Genesis Waste Management Facility - Modification 6 (MP 06_0139)
Jacfin Submission to Independent Planning and Assessment Commission
Site: Honeycomb Drive, Eastern Creek

Genesis Waste Management Facility - Modification 6 (MP 06_0139 MOD 6)
Jacfin Submission on Revised Response to Submissions
Site: Honeycomb Drive, Eastern Creek

Review of Revised Response to Submission Report and Air Quality Assessments for Genesis Waste Management Facility Modification 6 (MP 06_0139 MOD 6)

Figure 3-1. Terrain resolution as per AQIA at 500m interval (left), compared to recommended 150m resolution (right). Both the large scale valley features are not properly resolved, nor are the fine scale local affects around the facility.

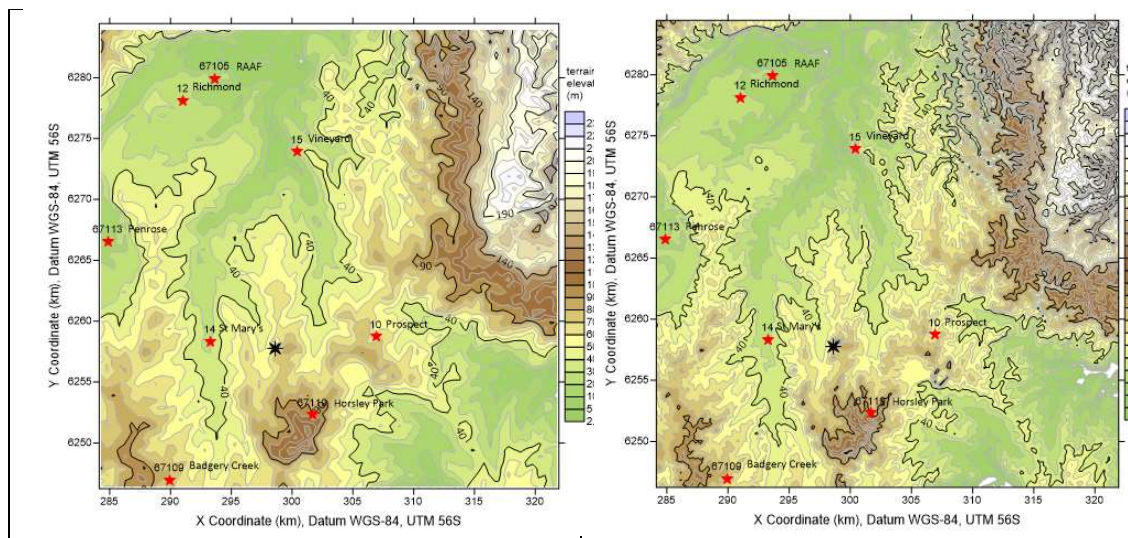
The AQIA modelling has underestimated the number of calms at the Facility. The evaluation of the CALMET model is incomplete and weak. The AQIA uses a very coarse model resolution of 500m instead of 150m-200m. (A terrain map with all the relevant weather stations has been overlaid at Figure 3-1).

Figure 3-1 shows the terrain used in the model in the AQIA model with a resolution at 500m compared to the recommended model resolution of 150m.

Therefore the result of the coarse terrain resolution used in the AQIA will have a couple of effects. The first is that the model will not respond to any topography that has not been resolved. This includes the subtle variations in topography around the site. Further, the topography that the model can 'see' is now much coarser than reality, i.e., it is not well resolved, such that the main valley is much less well defined. As a result the model is unable to determine either the large scale valley effects on the wind field at the Facility or the small scale local terrain effects. The net result of these effects is a wind rose at the Facility that has winds from all directions which means a less concentrated plume and better 'all round' dispersion than what is really happening.

Figure 3-2. ST Mary's OEH annual 2016 wind rose (left) compared to the AQIA CALMET wind rose at the Genesis site (rhs).

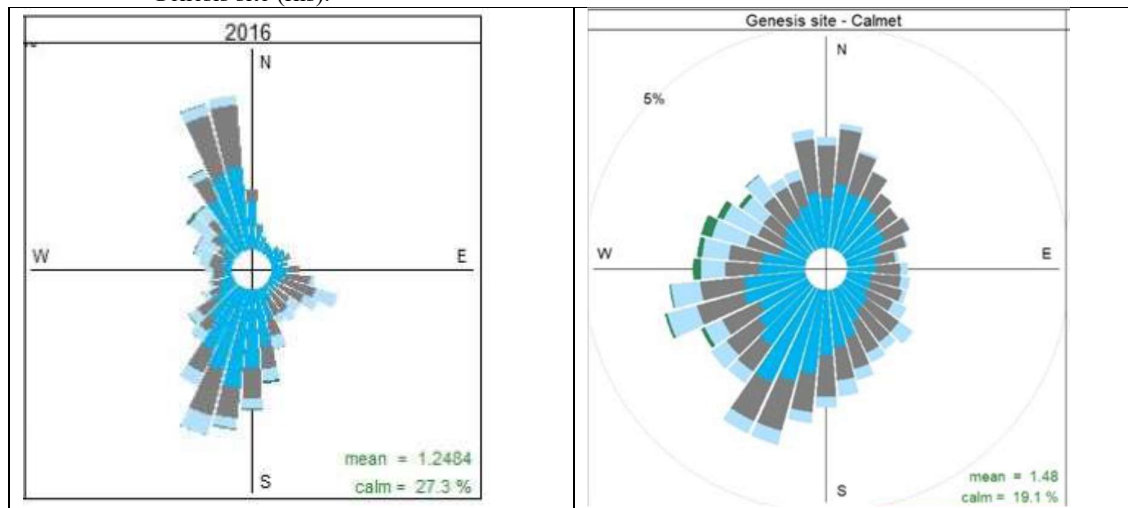
The wind regime around the Facility is controlled and directed by the local topography. This is especially the case as can be seen by the Horsley and St Marys wind roses. The Facility's wind rose should look more similar to St Marys than Horsley station as the Facility shares the same valley as the St Marys' weather station, and both experience northerly and south-westerly wind channelling caused by the mountains 18km to the west, as well as the minor valley in which the Facility is located. Figure 3-2 shows the 2016 annual St Marys wind rose compared to the CALMET wind rose at the Facility. The wind roses are quite different and the CALMET wind rose should look more similar to the St Marys wind rose.

The more uniform wind rose of the AQIA wind model at the facility will create better all round dispersion than is otherwise occurring, and it will also lessen the pit effects than would otherwise occur with a more realistic terrain channelled wind model.

Future modelling must create a more suitable wind field at the facility.

Accordingly, the Proponent's poor calculation of the wind field must be corrected to permit an accurate assessment of the air quality and odour impacts of the Modification.

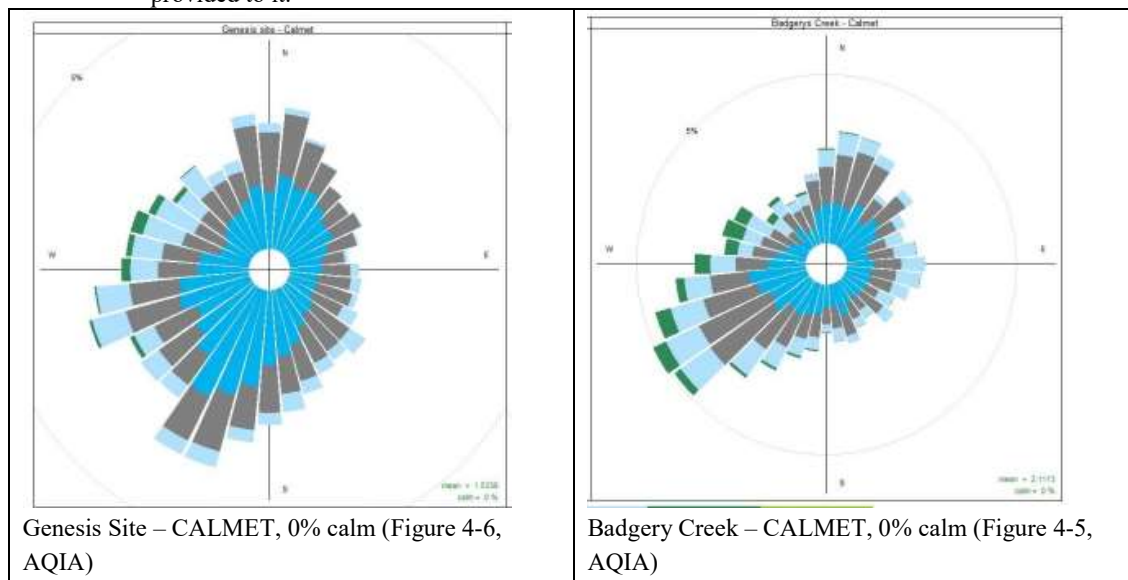
CALMET predicted 0% calms at the Badgerys Creek site (AQIA), but the Badgerys Creek BOM site recorded 7.4% calms. ASG has confirmed that the BOM site has 7% calms for the period of 2013-2015.

Further CALMET predicted 0% calms at the Facility (AQIA). In this same figure the AQIA reported 0.1% calm for Prospect which is incorrect. ASG has confirmed that the BOM Prospect site has 10% calms for the period 2013-2015. To under predict the actual number of calms is to underestimate the predicted ground level concentrations.

CALMET winds are incorrect. RtS Report has conflicting results about the number of calms.

Figure 3-4. Annual predicted wind roses at the Genesis site as documented in the RtS. One wind rose (left) shows 19% calm and the other shows 0% calm. The roses are otherwise identical.

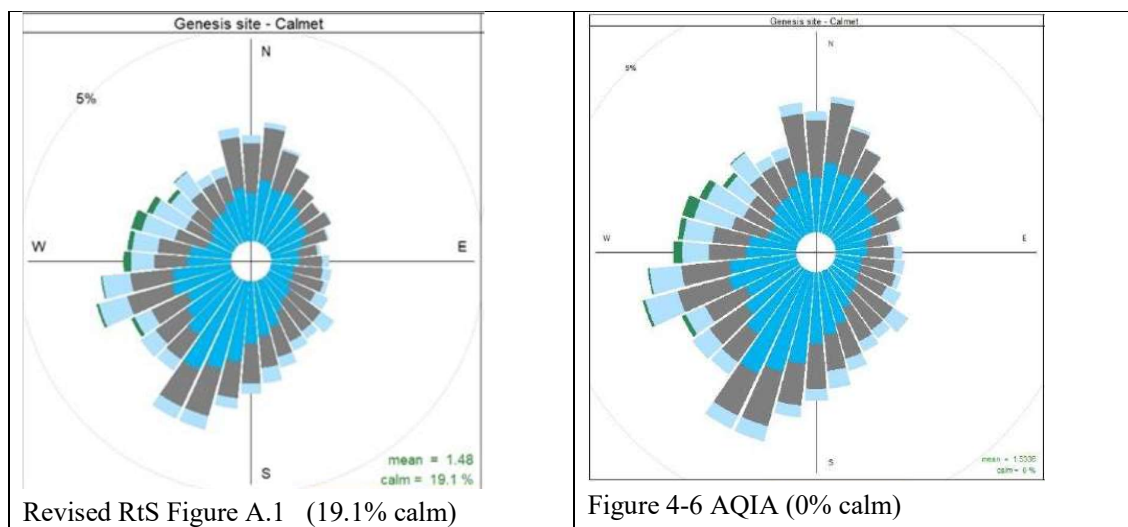
In Figure A.1 of the Revised RtS shows the predicted wind rose for the Facility has 19.1% calms compared to 0% in Figure 4-6. It is unclear why this is the case, and raises the question, whether the AQIA contains a significant error with respect to calm and light wind conditions? The note on the percent of calm conditions at the bottom right hand side of the wind plots are automatically produced by the plotting program and are a reflection of the data being plotted.

It was also noted that the wind rose wind speed scales are the same, such that the wind rose plot for 19% calms are identical to that for the 0% calms. CALMET should have predicted some calms, but the AQIA must reflect the model predictions correctly. Unfortunately, whether this is an error or not, does not provide any confidence in the surface meteorological data set. If the AQIA has under predicted the number of hours of calm conditions then they will have under predicted the ground level concentrations.

Figure 1 – Overall Recovery if 700,000 t recovered

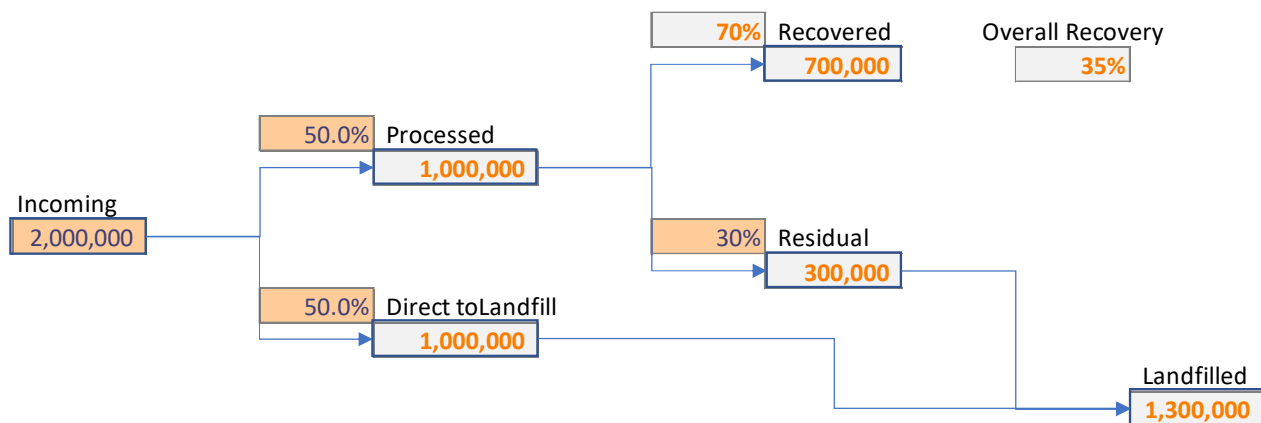
The maximum amount of material allowed to be accepted into the site each year is 2 million tonnes. If up to 1 million tonnes is sent straight to landfill this means that the amount processed through the MPC and PSB would be no more than 1 million tonnes. Of this, up to 700,000 t is stated to be recovered through processes at the site. This equates to just 35% of the total 2 million tonnes, significantly less than the 60% stated to be currently recycled. This is shown in Figure 1.

Figure 2 – Overall Recovery of 500,000 t recovered

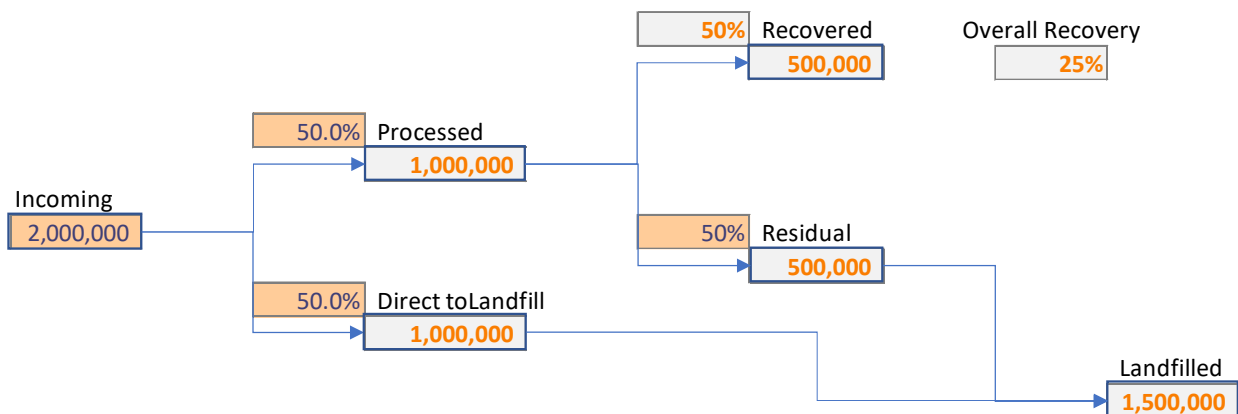
If less than 700,000 t is recovered, for example 500,000 t, then overall recovery would be as low as 25% and as much as 1.5 million tonnes landfilled at the site. This is shown in Figure 2 below.
